Quality Control Report

ConsultantWahib Medanat Consultant EngineersRep No.QC-21 09Site NameHay Al Iskan Basic mixed - JerashDate3 / 06 / 2021

Package Package 2

Contractor Dijlah Est. Construction Co.
Tender No. 10/2019/USAID/SKEP/3/2

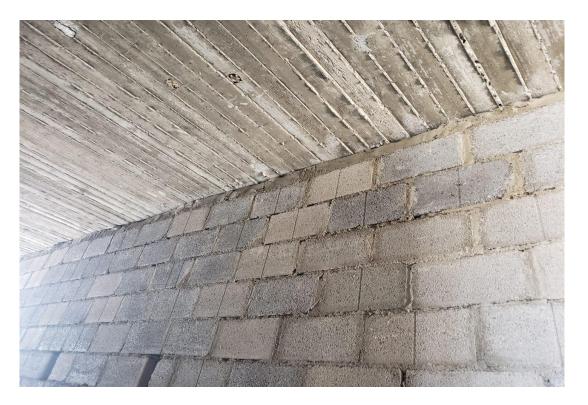
Tender No. 10/2019/USAID/SKEP/3/2		
Description of Non Conformance	Corrective Action	Required by / When
Narrow spaces in block walls must not be filled with mortar	Saw cut blocks must be used.	The Contractor/Immediately
Report Prepared by	Hassan Shaqbua, Supervision Quality Control Manager	
Contractor's Response		
The Contractor has taken immediate action.		
Notes	I
